Change Order - Construction Manager-Adviser Edition

PROJECT *(Name and address):*
Seven Oaks Elementary School
District 5 of Lexington & Richland Counties
1020 Dutch Fork Road
Irmo, South Carolina 29063

CHANGE ORDER NUMBER: 001
INITIATION DATE: July 20, 2010

SK-E043

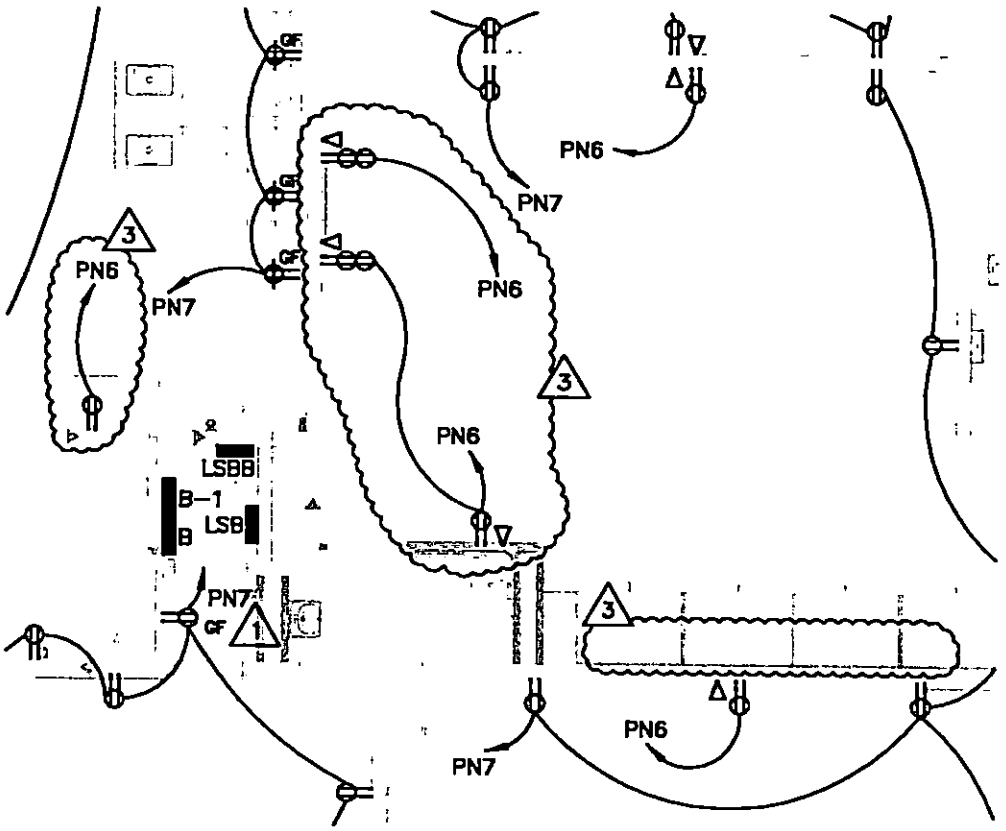
Description	Material	Labor	Sub & Misc
1	Provide and install material and labor	* 675	* 2,480	* 625
	required to install restoom shown in			
	revised sheet A1.05, SK-E043, SK-E044,			
	SK-E045, RFI #65, SK-M001, SK-M002,			
	SK-M003, SK- P001, SK-P002, SK-P003,			
	and SK-P004.			
	Electrical			HR Allen 1,438
2	Epoxy flooring			* 3,500
3	HVAC/Plumbing			W/W 5,409
4	Toilet Accessories	NewSouth ✓399	* 168	
5	Drywall			Bonitz 3,080
6	Wood doors, HM frames, and hardware	* 2,250	* 135	* 285
7	Casework			* 350
	Subtotal	$ 3,324	$ 2,783	$ 14,687
	Sales Tax @ 7.00%	$ * 233	—	—
	Subtotal	$ 3,557	$ 2,783	$ 14,687
	O. H. & Profit @ 15% 7.0%	$ 534	$ 417	$ 1,028
	Subtotal	$ 4,091	$ 3,200	$ 15,715
	Bond @ 1.44%	$ 59	$ 46	$ 226
TOTALS		$ 4,150	$ 3,246	$ 15,941

REVISED FLOOR FINISH PLAN @ MEDIA CENTER CLASSROOM NO. A141

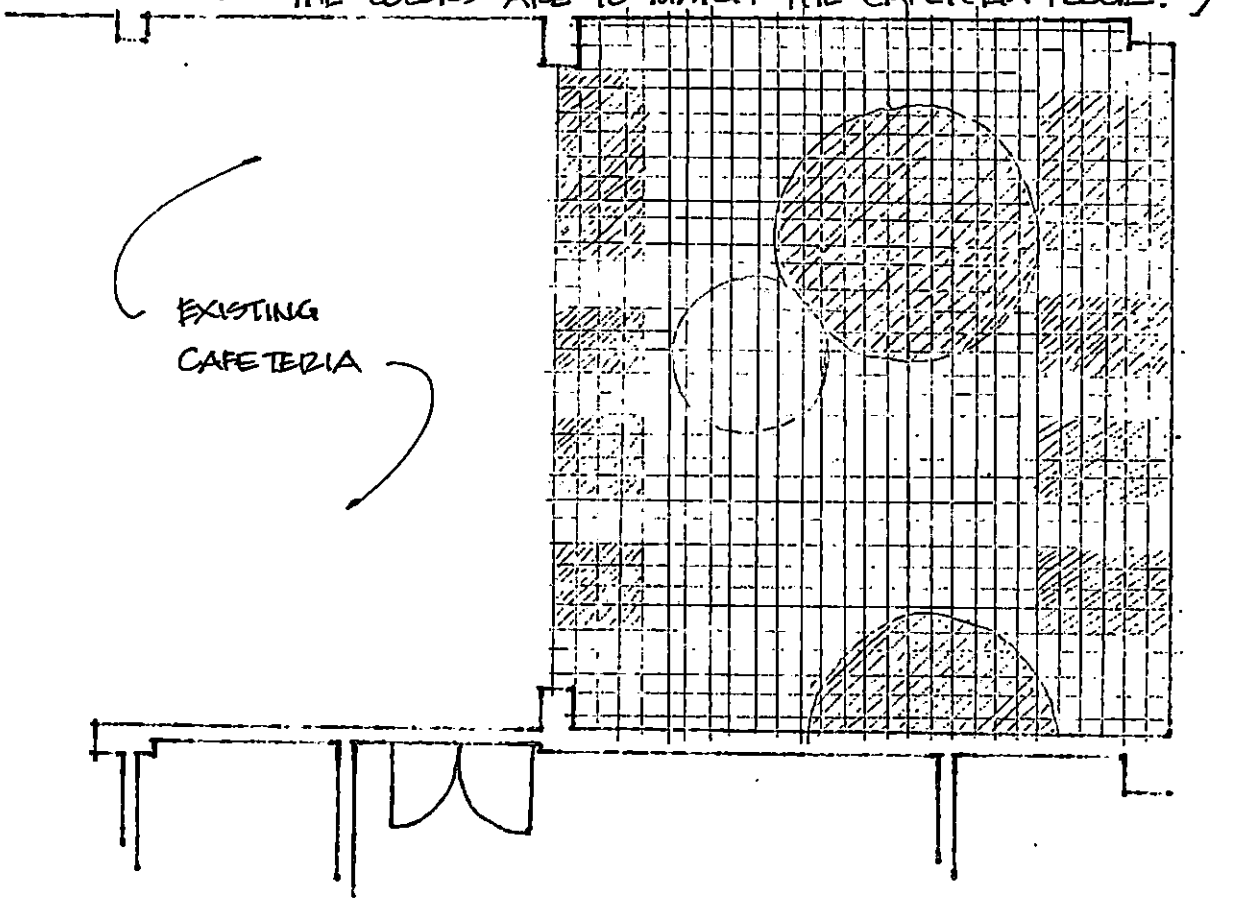
THE CARPETING IS TO BE REMOVED AND THE FLOOR PREPPED TO RECEIVE "ESTRIE" TILE. THE PATTERN SHOWN IS FOR REFERENCE ONLY. THE EXACT LAYOUT AND DIMENSIONS, ALONG WITH THE COLORS ARE TO MATCH THE CAFETERIA FLOOR.
